**Economic Commission for Europe****Inland Transport Committee****World Forum for Harmonization of Vehicle Regulations****Working Party on Passive Safety****Seventy-fourth session**

**Regulation No. 100 (Electric power trained vehicles)****Proposal for the 04 series of amendments to  
Regulation No. 100 (Electric power trained vehicles) \*****Submitted by the expert from the Netherlands**

Model A

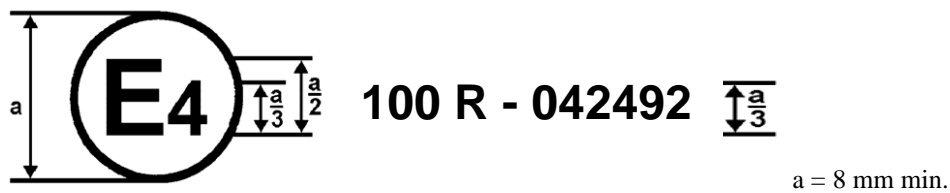
The approval mark in Figure 1 affixed to a vehicle shows that the road vehicle type concerned has been approved in the Netherlands (E 4), pursuant to Regulation No. 100, and under the approval number 042492. The first two digits of the approval number indicate that the approval was granted in accordance with the requirements of Regulation No. 100 as amended by 04 series of amendments.

The approval mark in Figure 2 affixed to a REESS shows that the REESS type ("ES") concerned has been approved in the Netherlands (E 4), pursuant to Regulation No. 100, and under the approval number 042492. The first two digits of the approval number indicate that the approval was granted in accordance with the requirements of Regulation No. 100 as amended by 04 series of amendments.

Model B

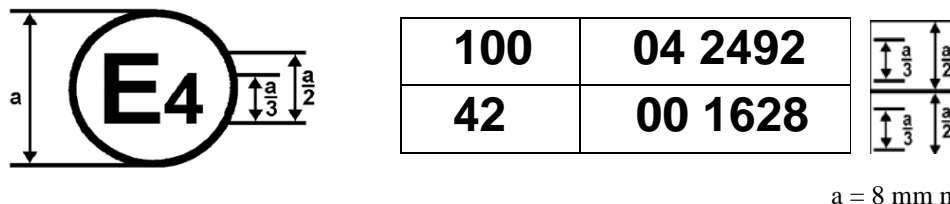
The above approval mark affixed to a vehicle shows that the road vehicle concerned has been approved in the Netherlands (E4) pursuant to Regulations Nos. 100 and 42<sup>1</sup>. The approval number indicates that, at the dates when the respective approvals were granted, Regulation No. 100 was amended by the 04 series of amendments and Regulation No. 42 was still in its original form."

## "Annex 10

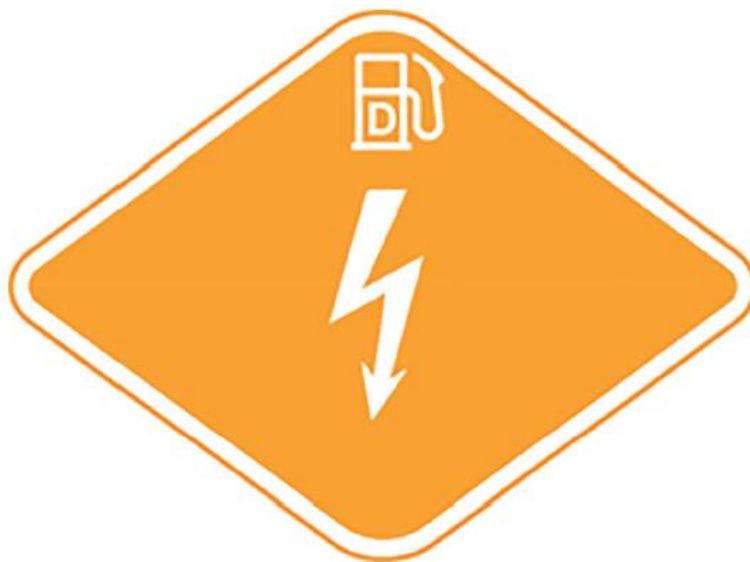
### Provisions for a label for vehicles of categories M<sub>2</sub>/N<sub>2</sub> and M<sub>3</sub>/N<sub>3</sub> equipped with an electric power train.

(Paragraph 5.5.1 to 5.5.3. of this Regulation)

The label shall be weather resistant.

The centre zone indicates the first energy source.

The upper zone indicates the second energy source.

Layout and symbols shall be in accordance with ISO 17840-4:2018.

Background:	Orange, RGB code 255, 165, 0
Border:	white reflecting
Letters:	white reflecting

Sticker width:	≥ 110 mm
Sticker height:	≥ 80 mm"
